**Agenda**  
**Tolland Planning & Zoning Commission**  
21 Tolland Green, Tolland, Connecticut  
Monday, April 25, 2022 at 7:00 p.m., 6<sup>th</sup> floor – Council Chambers

6. **Public Hearing(s)**
  - 6.1. **PZC #22-3 – 10 Fieldstone Commons** – Special Permit and Site Plan per section 10-3.B to allow for a multi-family development at 10 Fieldstone Commons. Zone: Gateway Design District (GDD). Applicant: Fieldstone Ridge, LLC.

**TO:** Planning and Zoning Commission

Re: **Fieldstone Ridge, 10 Fieldstone Commons  
Site Plan Review**

**INFILTRATION GALLEY (Buildings 12, 13, 14 & 15)**

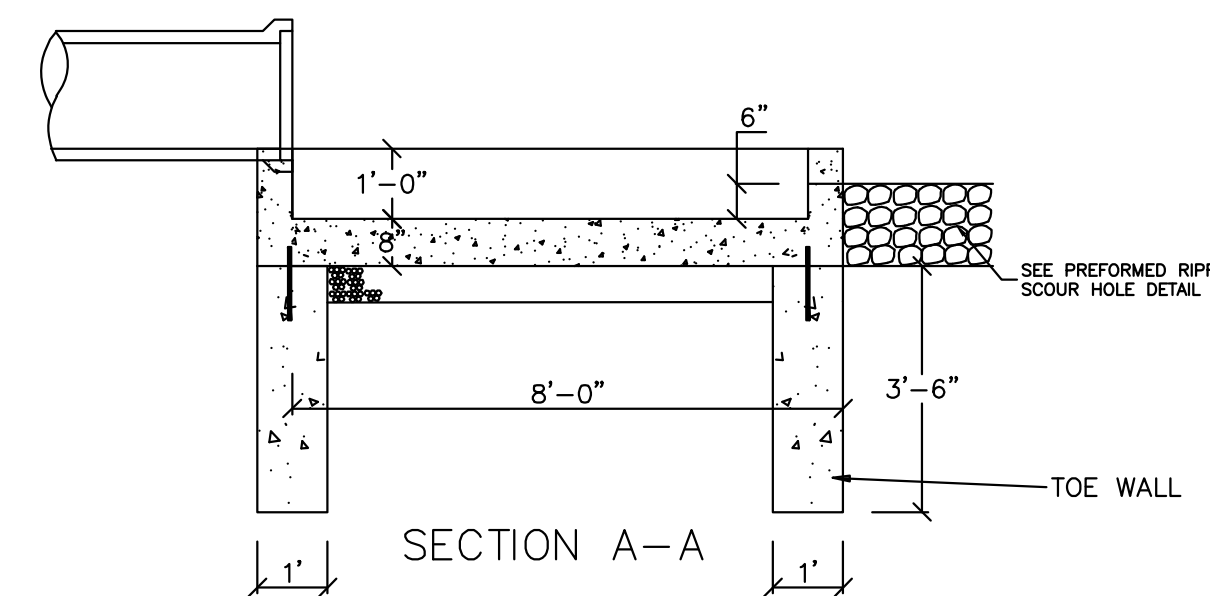
24. Pursuant to the Tolland LID Manual, the sides of the infiltration chambers must be lined with a non-woven filter fabric to prevent soil piping. The infiltration galley detail must be updated to reflect this.

SCREEN FENCING DETAIL

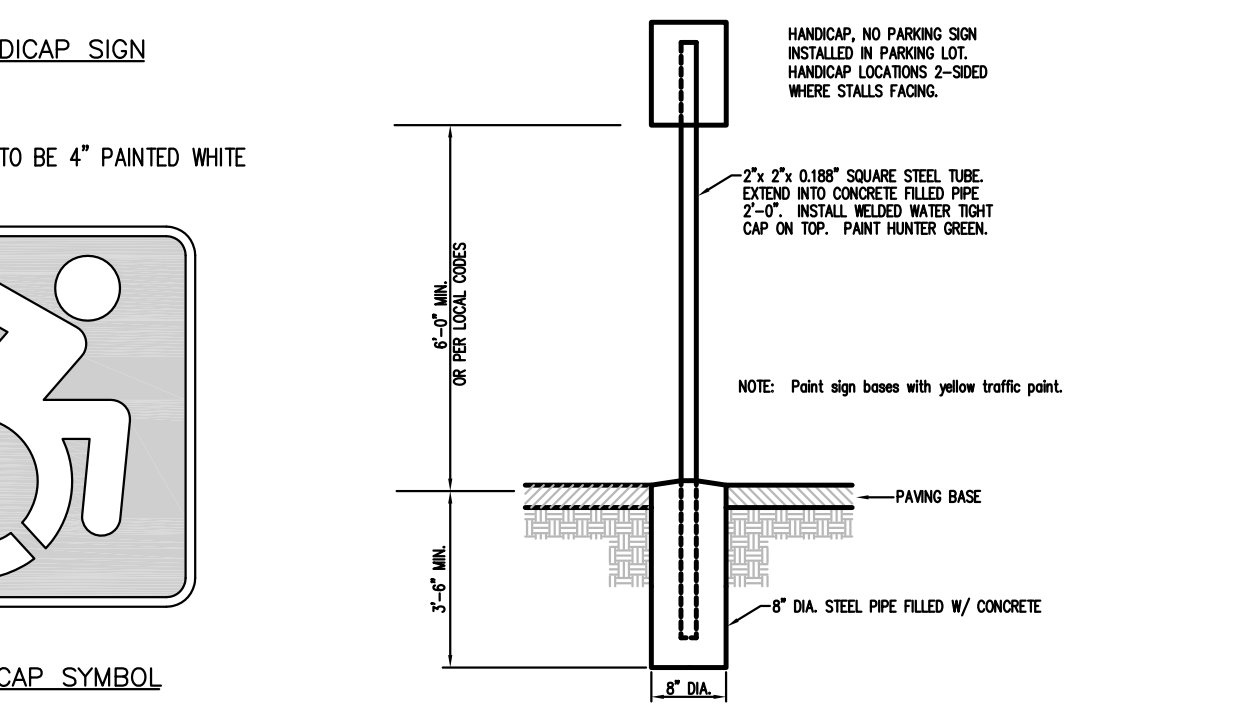
4. The proposed dumpsters call for a screening fence; however, this must be further detailed and described on the plan set.
